Access Compliance Report

Public Rights-of-Way

Intersection ID: 47573	Main Street: SEDGEBURN_DR	Cross Street: GAILES_DR	Location: SW
ADA ID: F124538B205A	Ramp Type: PerpDiag	Initial Pass/Fail: Fail	Overall Compliance: No
Codes/Mitigation Info/Possible Solution		Field Measurements/Component Compliance

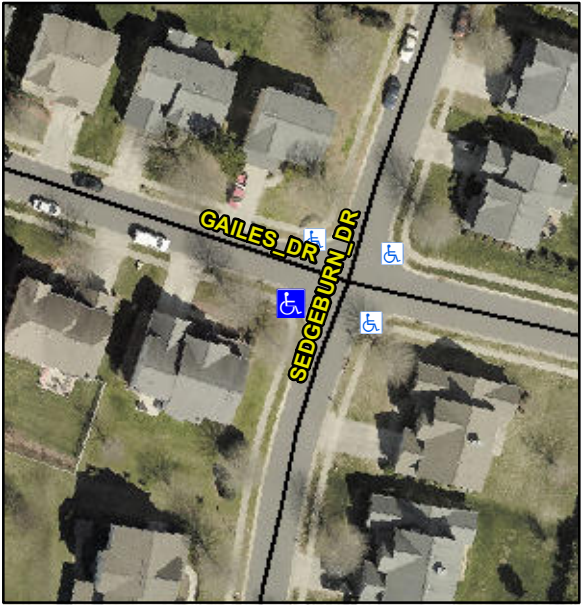
Possible Solutions:			
	Remove & Replace Curb Ramp With Two New Directional Ramps or Equivalent.			
<p>Surveyor Notes:</p> <p>N/A</p>	<p>PROW/ADA:</p> <p>R304.2.2, R304.5.3</p>	Compliance	Description	Data
		N/A	Ramp Length (in)	47.0
		Yes	Ramp Width (in)	48.0
		N/A	Flare Type LT	N/A
		N/A	Flare Slope LT (%)	N/A
		N/A	Flare Traversable LT?	N/A
		N/A	Landing Length (in)	N/A
		N/A	Landing Width (in)	N/A
		N/A	Landing Slope (%)	N/A
		N/A	Landing X Slope (%)	N/A
		N/A	Landing Curb? (Y/N)	N/A
		N/A	Shared Landing?	N/A
		N/A	Gutter Ponding?	N/A
		N/A	Gutter Lip Ht (in)	N/A
		N/A	Painted X Walk1?	No
			X Walk 1 Direction	To SE
		N/A	X Walk 1 Width (in)	N/A
			X Walk 1 Slope (%)	5.4
			X Walk 1 X Slope (%)	0.4
		N/A	Ramp inside XWalk1?	N/A
			Road Slope (%)	2.8
			Road X Slope (%)	1.9
		N/A	Any Obstructions?	N/A
			Obstruction Type	
				N/A
		Yes	Surface Condition? (G/P)	Good
